B. **VARIANCE REQUEST, MONSIGNOR ZOUHAIR TOMA KAJBOU, 2442 E. BIG BEAVER ROAD, ST. JOSEPH CHALDEAN CATHOLIC CHURCH –**

In order to construct an addition to the church and a new driveway: 1) An 8 foot variance from the requirement that the addition be set back 50 feet from the west property line, 2) a 43 foot variance from the requirement that the proposed driveway be set back at least 50 feet from the west property line, and 3) a variance from the requirement that a landscaped berm be provided between the proposed driveway and the west property line.

Preliminary Site Plan For City of Troy, Michigan

Applicant:	Monsignor Zouhair Toma Kajbou
Project Name:	St. Joseph Chaldean Catholic Church Renovations
Plan Date:	Submitted to Troy Planning Department December 3, 2010
Location:	2442 East Big Beaver Road
Zoning:	R1-E and RM-1
Action Requested:	Preliminary Site Plan Approval
Required Information:	Deficiencies noted

NORTH
PHOTOMETRIC PLAN
SCALE: 1" = 30'-0"

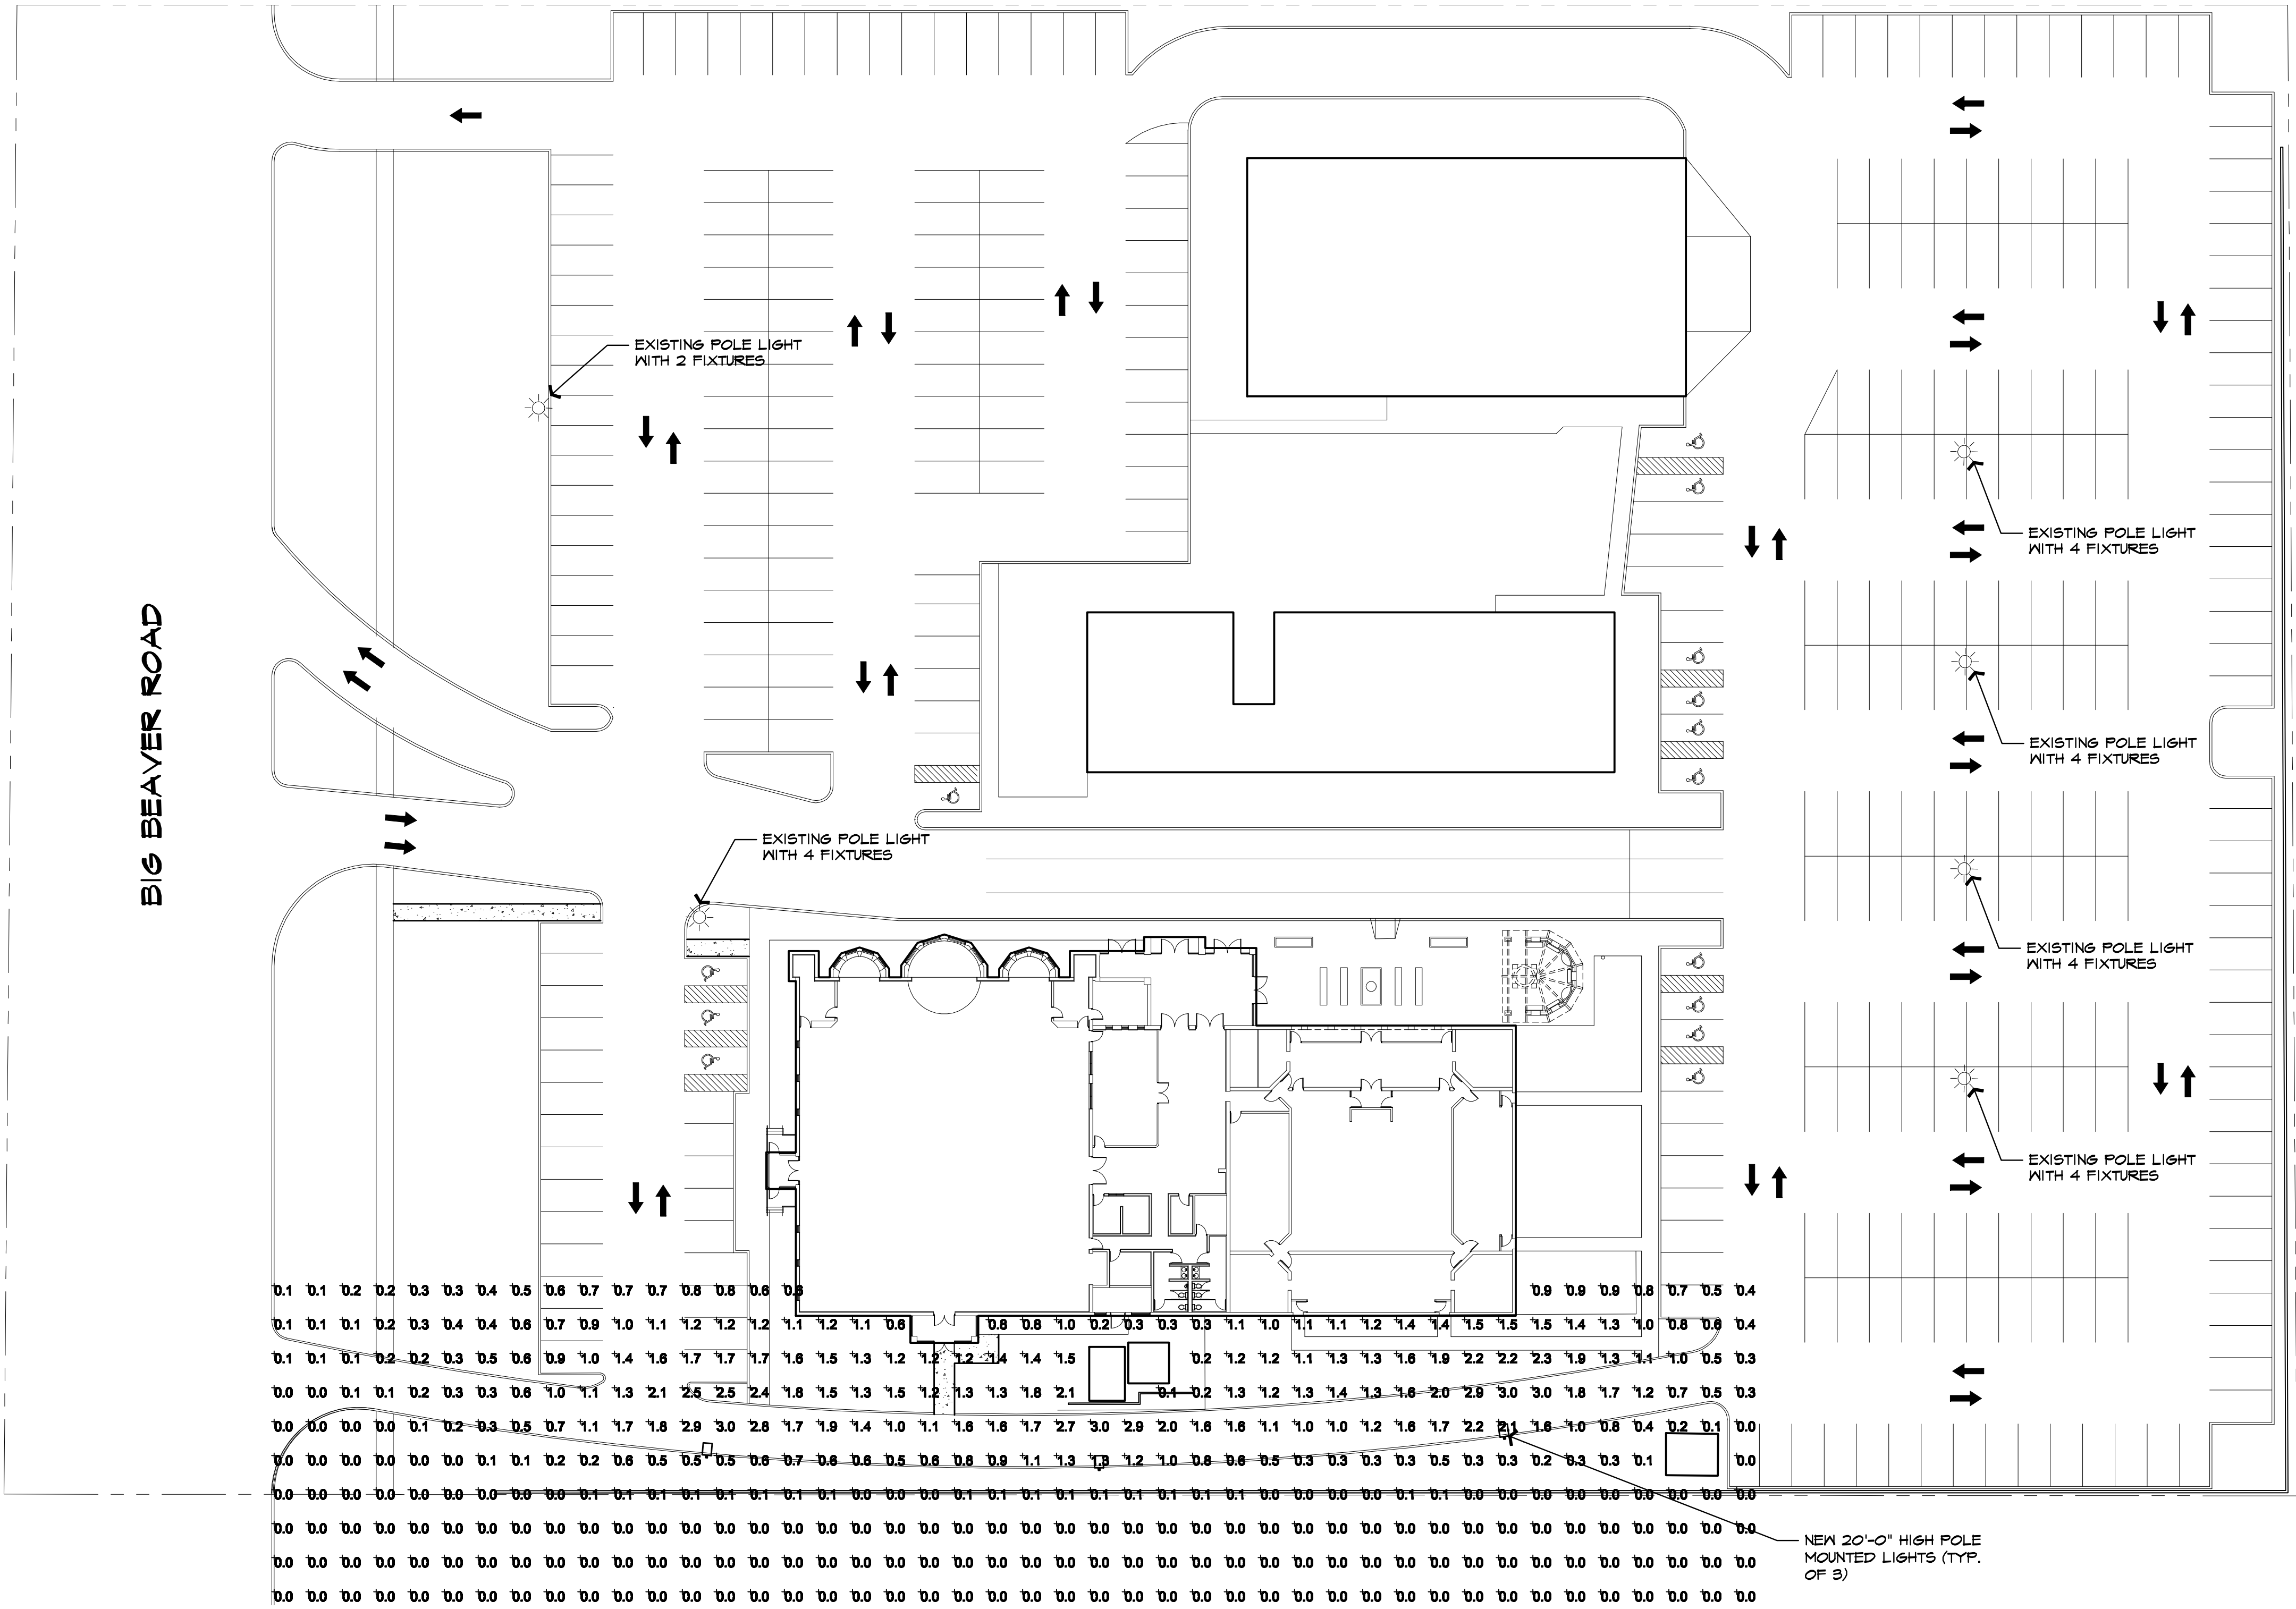
The applicant has not provided a photometric plan for this project. Full lighting details will be provided for final site plan approval.

- Potential for deceleration lane.
- Special Use standards applicable to site plan.
- Photometrics plan; impact of vehicular and building lights to adjacent residential.
- Landscaping.
- City owned property to the south.
